INFORMATION REQUEST RESPONSE

RESPONSE TO INFORMATION REQUEST – 25 PRINCE STREET, ANNERLEY (APPLICATION REFERENCE - A006876477)

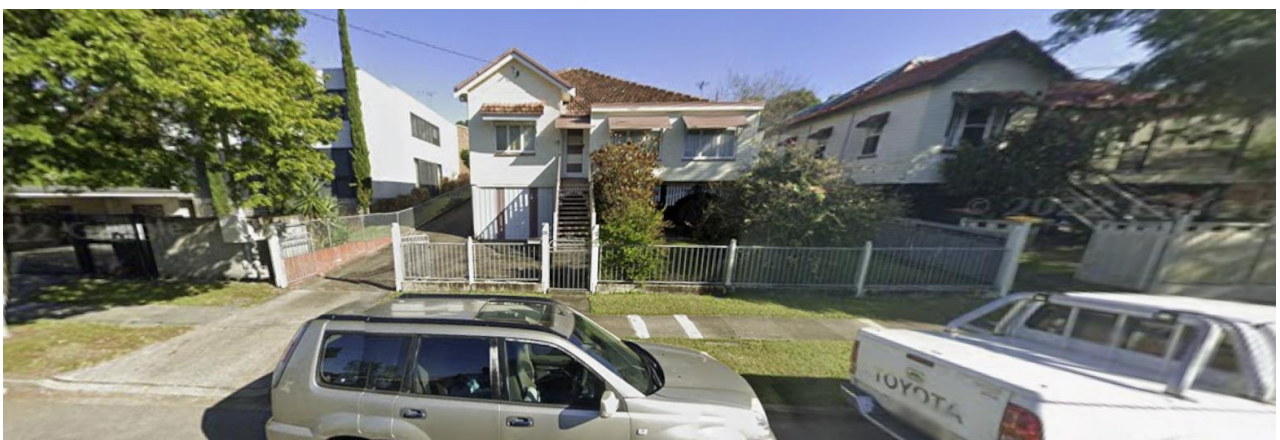
- b) *Provide streetscape elevation drawings of the proposed development, when viewed from Prince Street. The streetscape elevation drawings must demonstrate that the proposal accommodates a scale and form*

that is considerate to surrounding development and maintains a general bulk and scale which is consistent with adjoining buildings when viewed from the streetscape.

Response to Item 1b:

The revised plans include streetscape elevations, as shown below (also refer to Appendix 1). The proposed Dual Occupancy will largely be screened by the existing dwelling. Whilst it is acknowledged that the upper floor may be visible from Prince Street, we consider that this will be no different to if an extension was carried out to the existing house. Given the slope of the land, the extension would be 'stepped' up the slope, which would result in a similar outcome as the proposed development. Furthermore, the proposed Dual Occupancy does not directly address streetscape. The streetscape will continue to reflect as it currently does, despite the Dual Occupancy located behind the existing dwelling house.

Figure 1: A comparison of the subdivision plan and site plan showing how the lot sizes have been calculated.

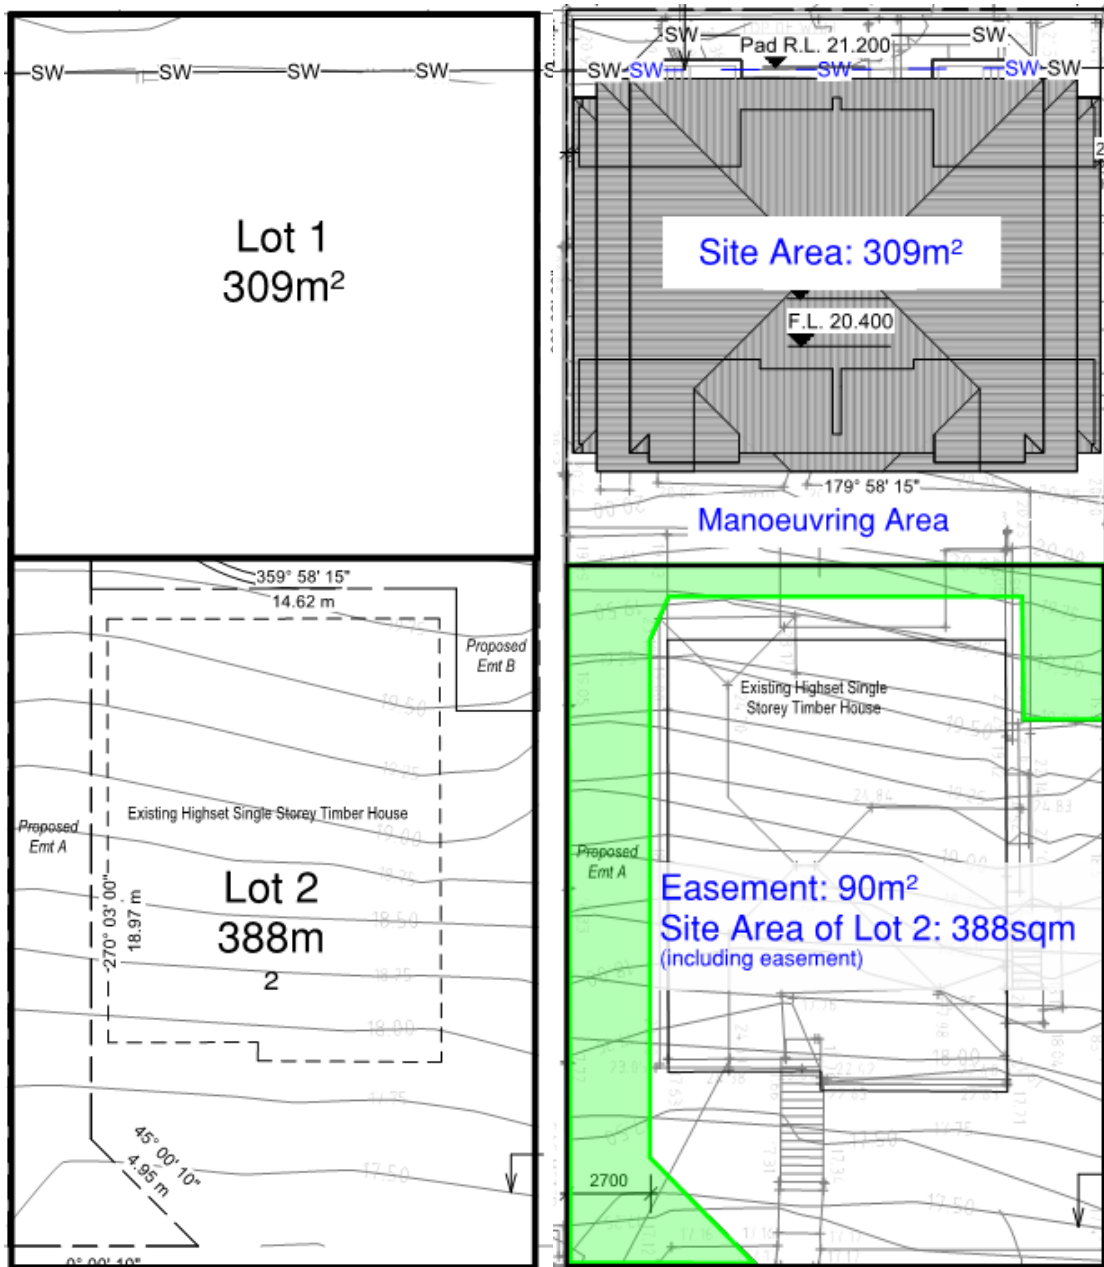
- 2) *The proposed lot layout plan indicates that lot 1 achieves an area of 309m², and lot 2 achieves an area of 388m². However, these lot areas as notated on the proposed plan appear to be inclusive of the access way to the rear lot and the proposed easement that also serves as an access way, therefore the proposed lot sizes as notated are incorrect.*
- a) *Provide amended plans ensuring the proposed lot sizes are correctly illustrated, excluding the access way to the rear lot and area of any easement that also serves as an access way. Provide an updated assessment accordingly against AO1.1/PO1 of the Subdivision code for further consideration from Council officers.*

Proposed Lot 2 incorporates the access easement within the lot size, which equates to 388m².

It is noted that Proposed Lot 1 will incorporate some easement within the lot, however, this is not considered part of the 'access easement/handle', which is to be excluded from the lot size. This area is the driveway, which is used for manoeuvring in and out of the site. This has been demonstrated in Figure 1.

Figure 3: The built to boundary wall on the northern boundary.

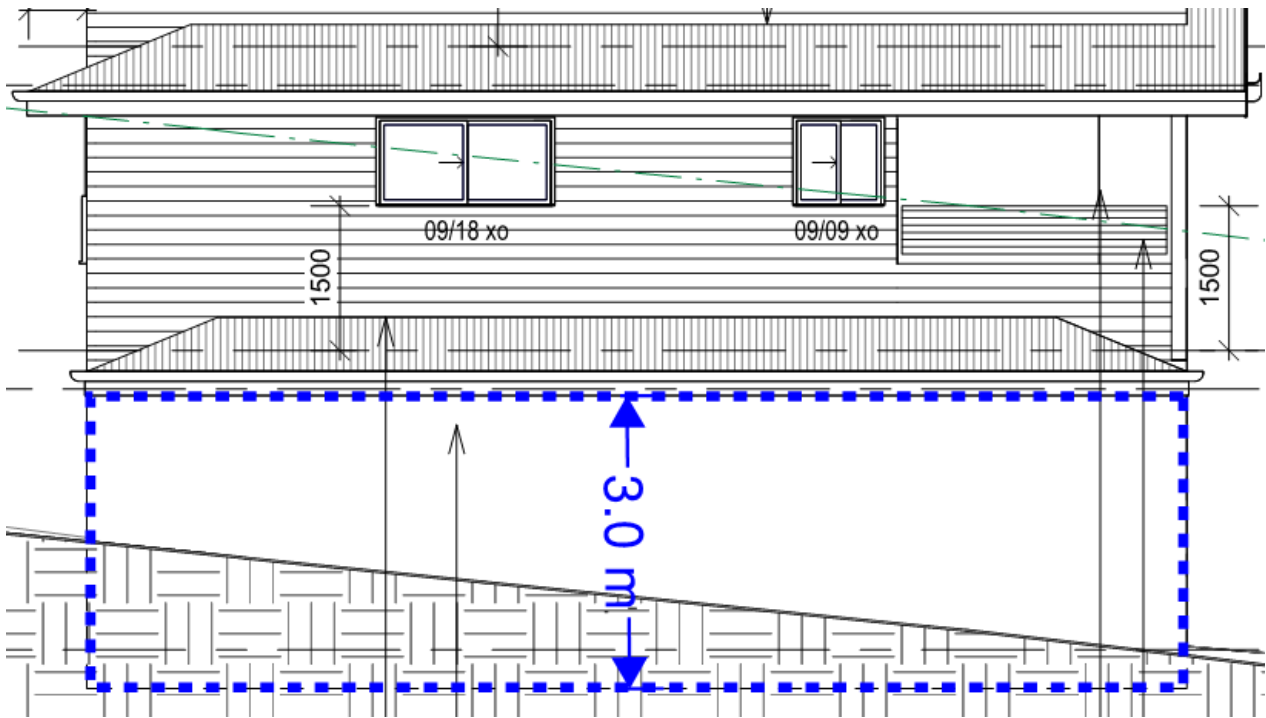
13) *Provide amended plans ensuring the proposed built to boundary wall on both the northern and southern elevation does not exceed 3m as stipulated by AO10.1 of the Dual occupancy code.*

As demonstrated in Figure 3 and 4, the built to boundary wall does not exceed 3.0m on the northern and southern elevations.
